# APPLICATION FOR PERMIT

Portland, Maine, July 7, 1941

Inclosed is the building permit covering erection of a camp on Wind-  
ing Way, Peaks Island which has been issued based upon the revised  
location plan which you have submitted today.

Referring to your application for a building permit to cover erection of a camp on Winding Way, Peaks Island, your location plan shows that you propose to erect this camp so that the rear wall will be less than twelve feet from the nearest point on the rear lot line.

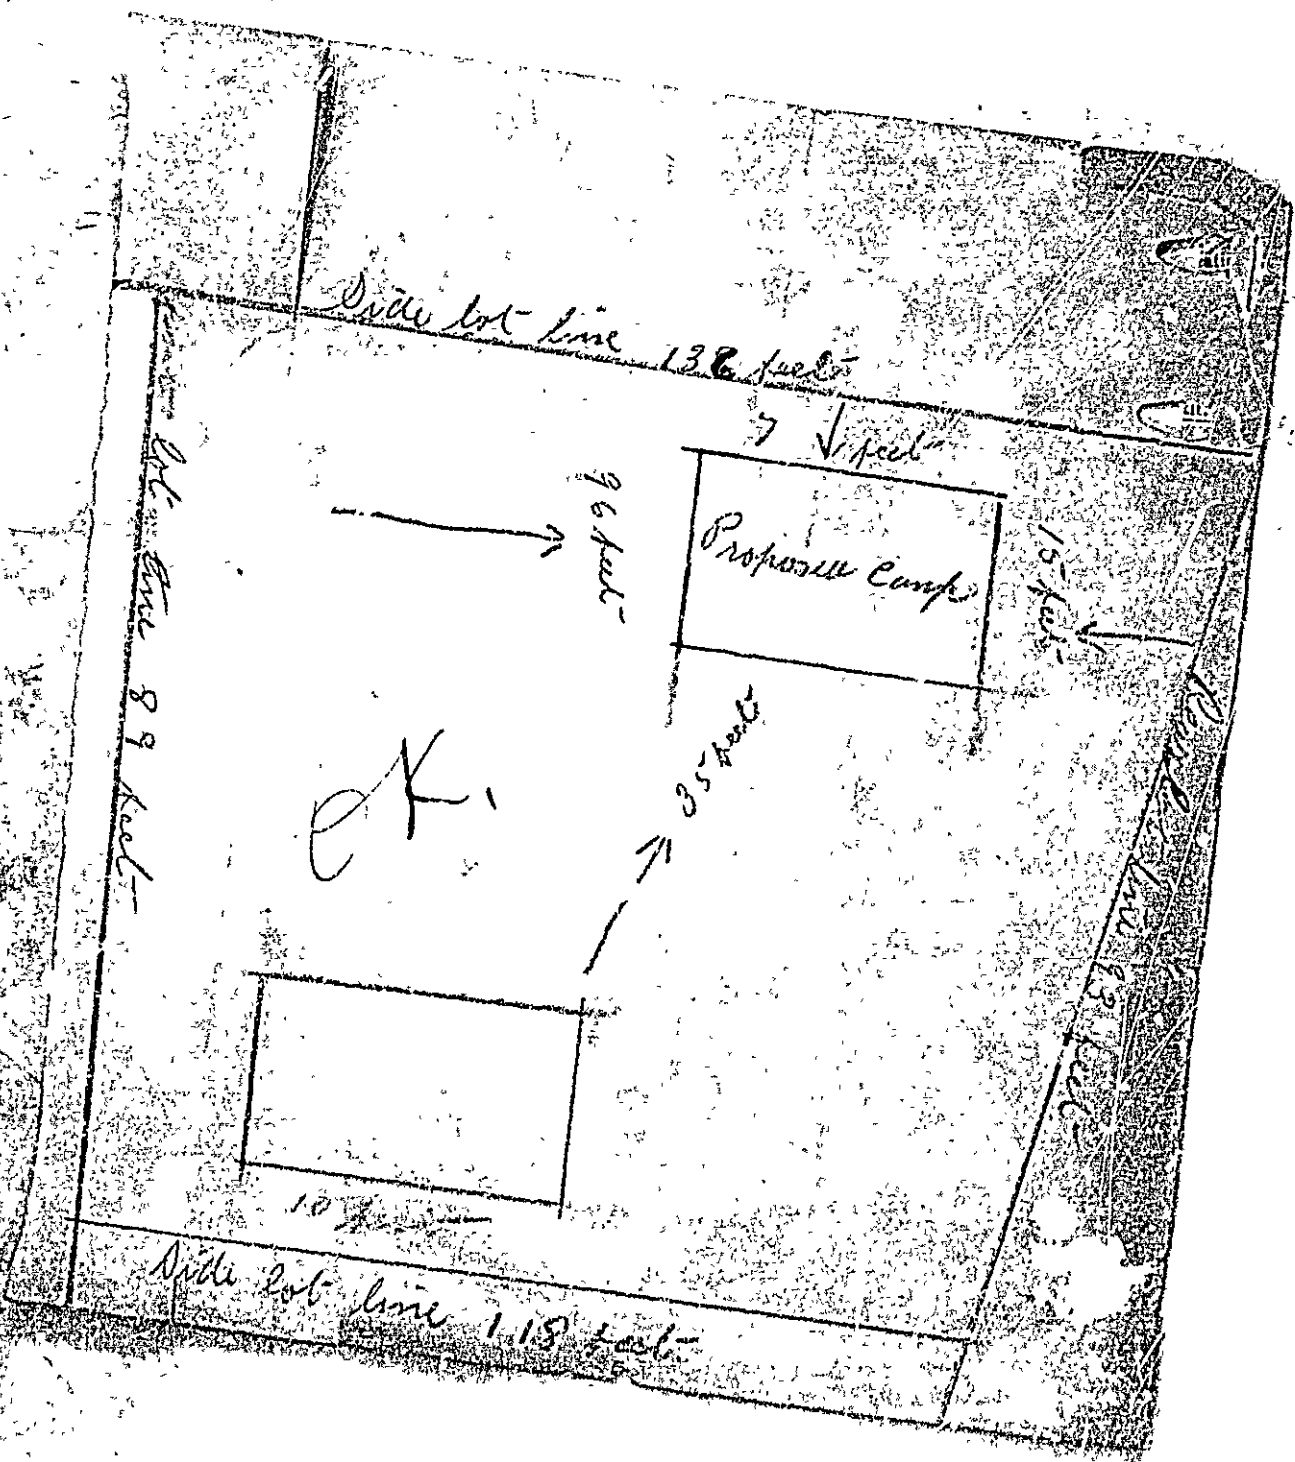
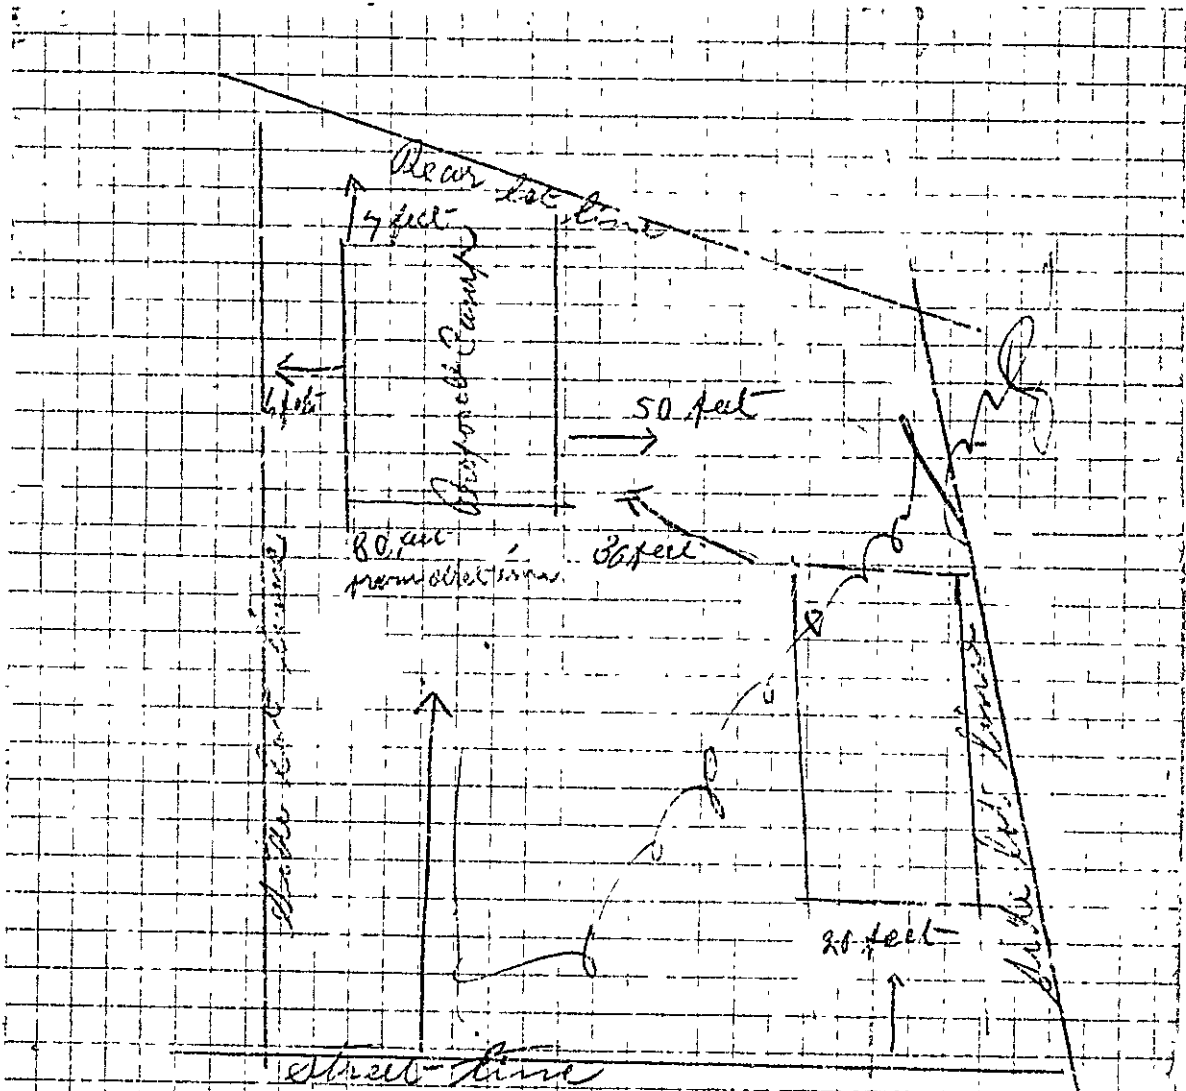
Your proposed building is located in an Apartment House Zone where an open space or yard of at least twelve feet is required between the extreme rear of the building and the rear lot line.

If you propose to observe this requirement, you should come to this office promptly and make the change upon your location.
